**AGENDA**  
**Planning & Zoning Commission**  
**Regular Meeting**  
**San Luis Council Chambers**  
**1090 E. Union Street**  
**San Luis, AZ 85349**  
**Tuesday, August 13, 2024**  
**6:00 P.M.**

## PLANNING & ZONING AGENDA ITEM REVIEW FORM

# BIENESTAR ESTATES 12 - PHASE 2 SUBDIVISION

# ORCHIDEA PARK PHASE 1

2619 S. Ave. 21/2, Ste 3 Yuma, Az 85365  
 928-329-0000 Tel 928-247-6232 Fax  
 www.vegaandvega.com

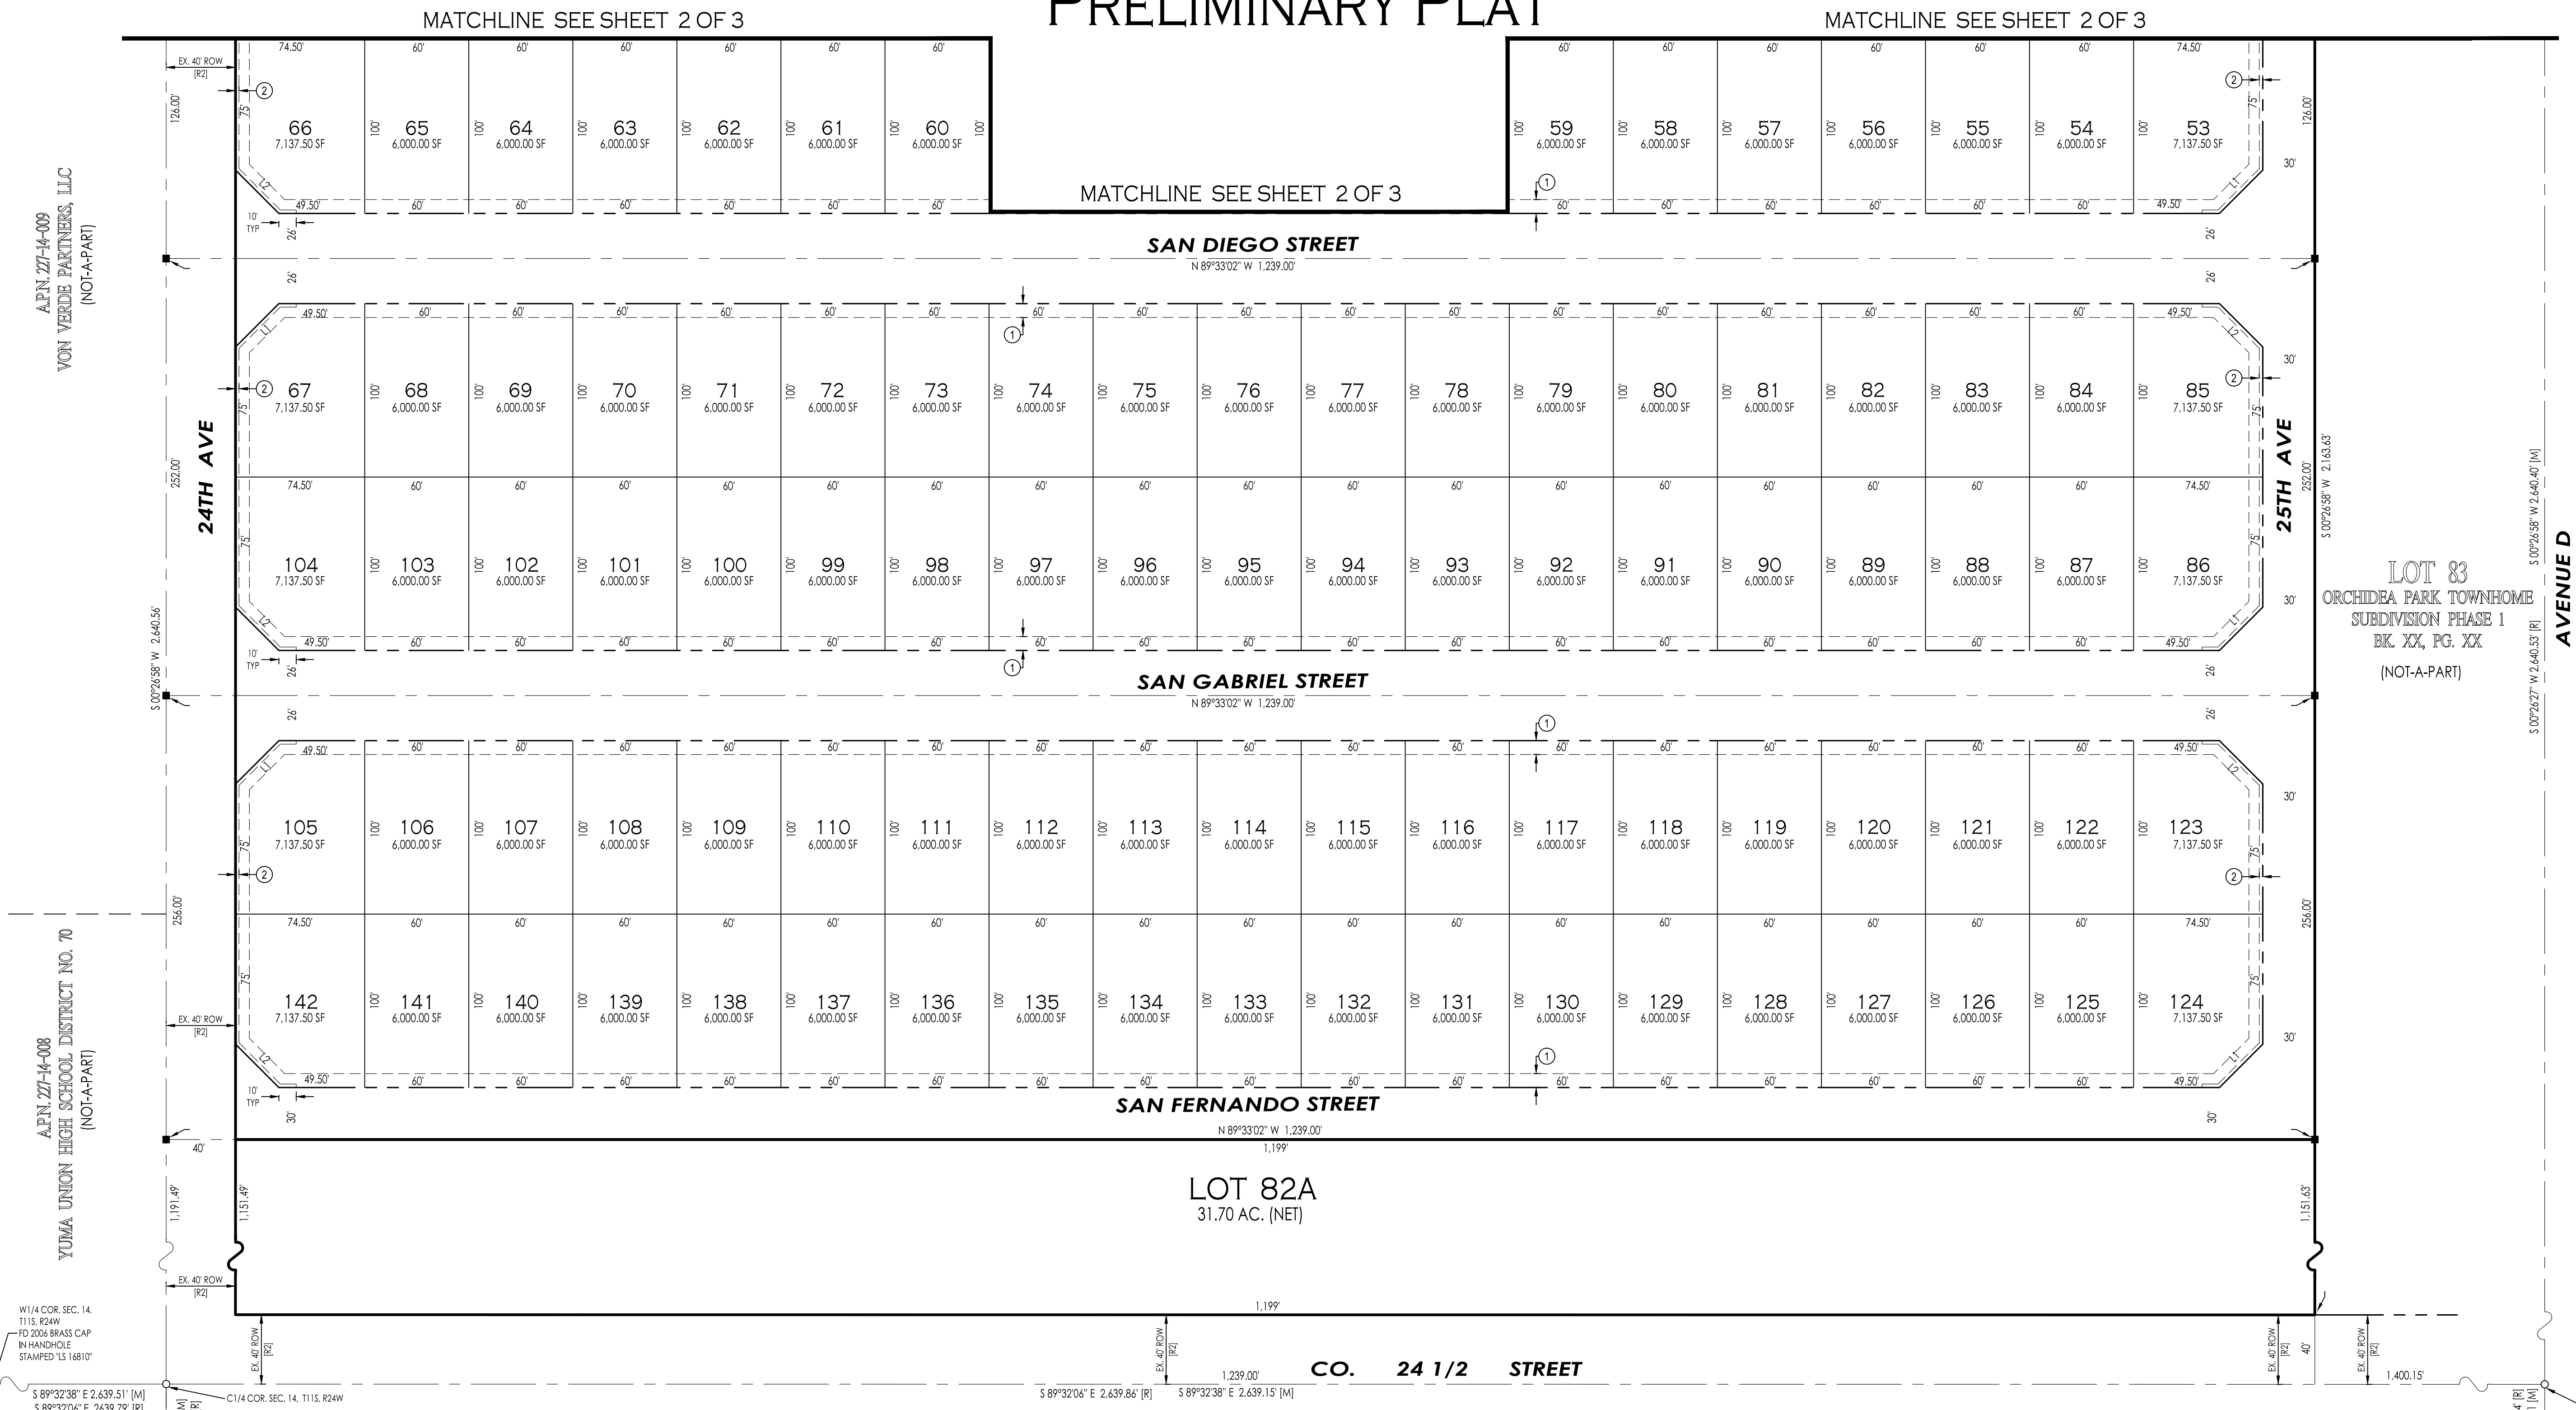
1. Provide CCR's and Title Report.
2. On Approved Section revise "Director of Planning and Zoning" to "*Director of Development Services*".
3. Add 1' NAE to lots that abut retention basin.
4. Legend - Reference survey monuments to COY standards.
5. As per current Subdivision Regulations subdivider will take such actions as may be necessary to form, establish and include the subdivision in an improvement district.

1. Submit complete drainage report and engineer design report.
2. Show existing elevation contours.
3. Provide guard post location and spacing on 13' spillways.

4. Keynotes No. 5 and 9 reference detail accordingly (revise all sheets).
5. Legend - Reference survey monuments to COY standards.
6. Provide slopes and dimensioning on retention basin.

7. Provide CMU wall on lots abutting retention basin.
8. Include barricade at the end of San Marcos Street, San Antonio Street, San Diego Street, San Gabriel Street, San Fernando Street, 25<sup>th</sup> Avenue and 24<sup>th</sup> Avenue.

9. Lot 124 seems to be shallow in comparison to curb elevation, verify or clarify accordingly.
10. For 24<sup>th</sup> Avenue section to match northern developments with a centerline to curb dimensions of 26.0' and 5' sidewalk.

11. General Notes: Update notes to reference City of San Luis.
12. Provide walking pathway on retention basing (east and west side) to connect San Antonio Street and San Diego Street.

13. Provide additional lighting on retention basin for common area recreational amenities.

1. Provide ADEQ permits.
2. Add dimension from centerline to water and sewer mains.
3. Sanitary sewer manholes need to be polymer manholes as per City of San Luis Supplement to the MAG Uniform Standard Specifications.
4. Provide fire hydrant street markers as per COY Std. No. 5-160.

1. Assure design meets City of San Luis Standards. Any deviations from City Standards need City of San Luis approval prior to incorporating into the design. Update General Note No. 1 to reflect this.
2. Provide traffic study for this development and how it incorporates to proposed improvements from Mezquites and Von Verde traffic study by Nicklaus Engineering for this area.
3. As a recommendation – provide a pedestrian path be connecting the two street at the retention basin.

1. Add perimeter wall might be missing around the retention basin.
2. Include all necessary end of street barricades.
3. Suggest that CMU wall callout be modified so that the 6 foot height requirement is on the side of highest elevation.
4. The City uses dual mast arm street lights next to retention basins. Final street light design will be coordinated with APS.

1. Outlet headwall detail doesn't apply.
